**SUNDRY NOTICES AND REPORTS ON WELLS**  
*Do not use this form for proposals to drill or to re-enter an abandoned well. Use Form 3160-3 (APD) for such proposals.*

8. Well Name and No.  
Rosa Unit #380

## PLUG AND ABANDONMENT PROCEDURE

Re: Permanent Abandonment  
Well: Rosa Unit #380

## ROSA UNIT #380- Proposed P&A BASIN FRUITLAND COAL

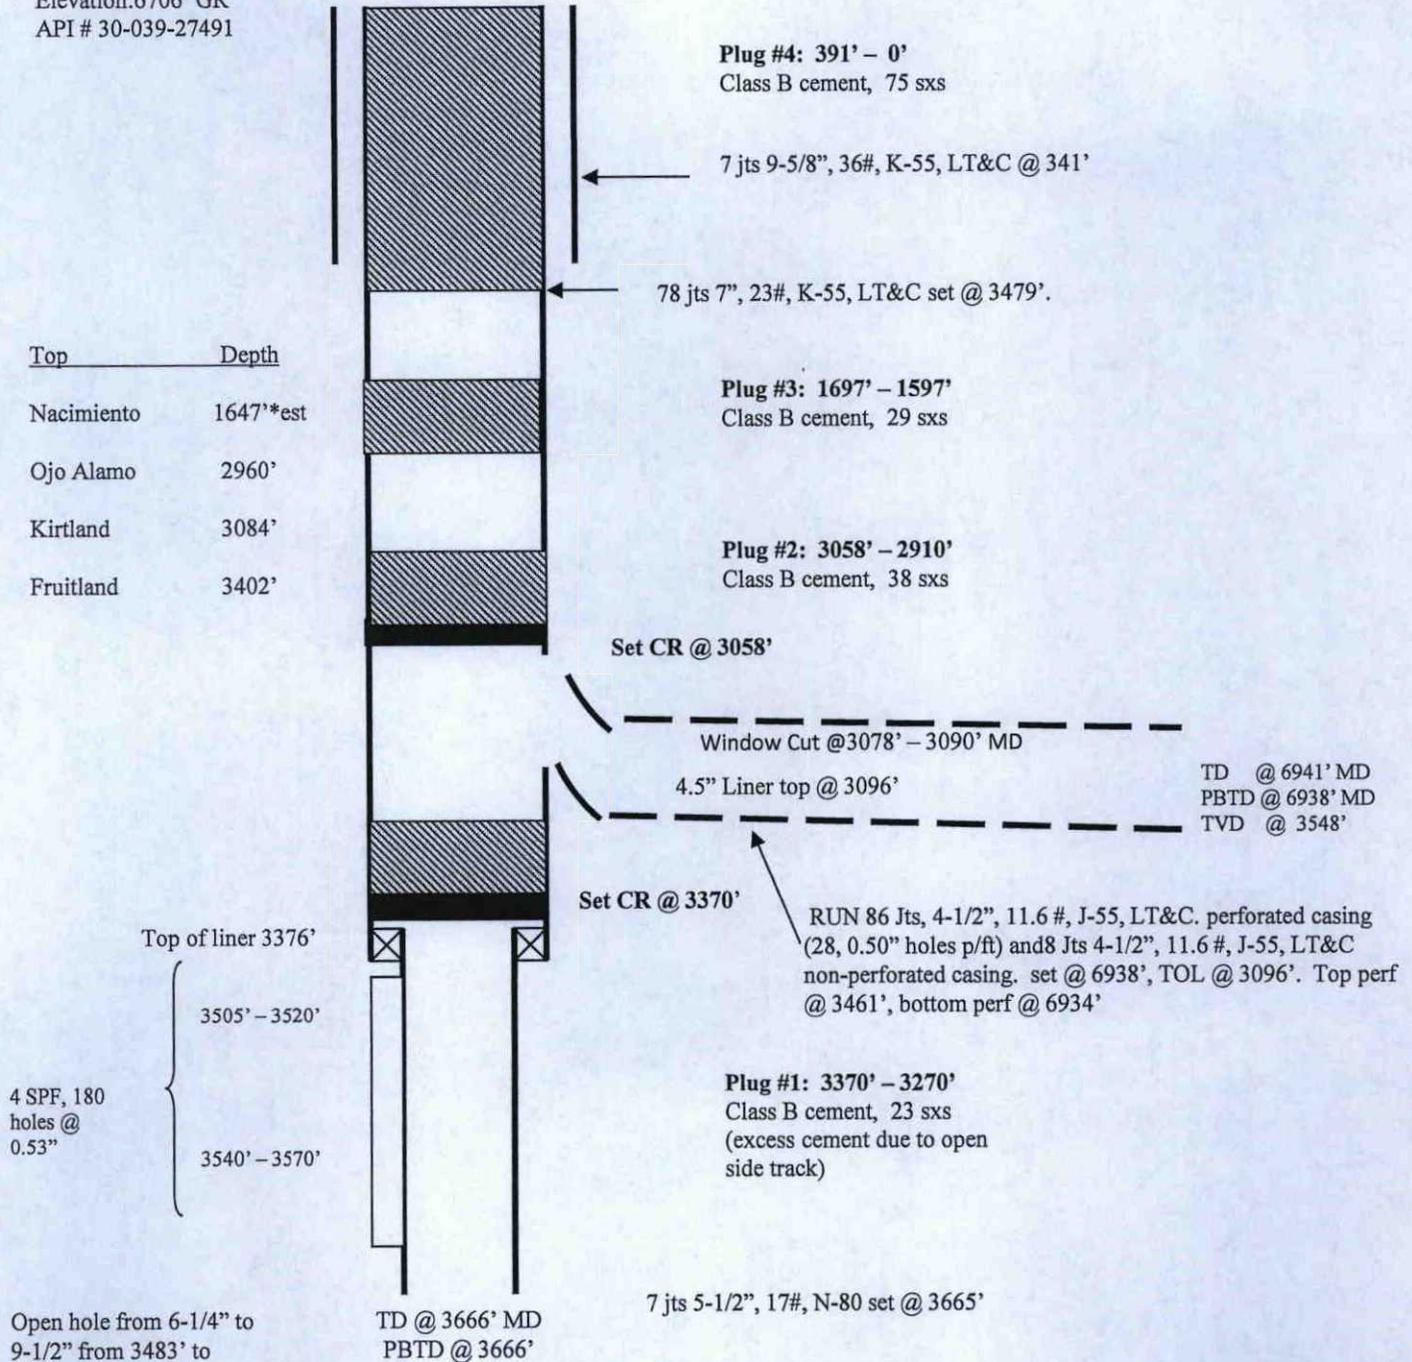
1. Plugging operations authorized are subject to the attached "General Requirements for Permanent Abandonment of Wells on Federal and Indian Lease."
2. Farmington Office is to be notified at least 24 hours before the plugging operations commence (505) 564-7750.
3. The following modifications to your plugging program are to be made:
  - a) Bring the top of plug #1 to **3219 ft.** to cover the Fruitland top. **BLM picks top of Fruitland at 3269 ft.** Adjust cement volume accordingly.
  - b) Set plug #3 (**1744-1644**) ft. to cover the Nacimiento top. **BLM picks top of Nacimiento at 1694 ft.**

1. Plugging operations authorized are subject to the attached "General Requirements for Permanent Abandonment of Wells on Federal and Indian Lease."
2. Farmington Office is to be notified at least 24 hours before the plugging operations commence (505) 564-7750.
3. The following modifications to your plugging program are to be made:
  - a) Bring the top of plug #1 to **3219 ft.** to cover the Fruitland top. **BLM picks top of Fruitland at 3269 ft.** Adjust cement volume accordingly.
  - b) Set plug #3 (**1744-1644**) ft. to cover the Nacimiento top. **BLM picks top of Nacimiento at 1694 ft.**
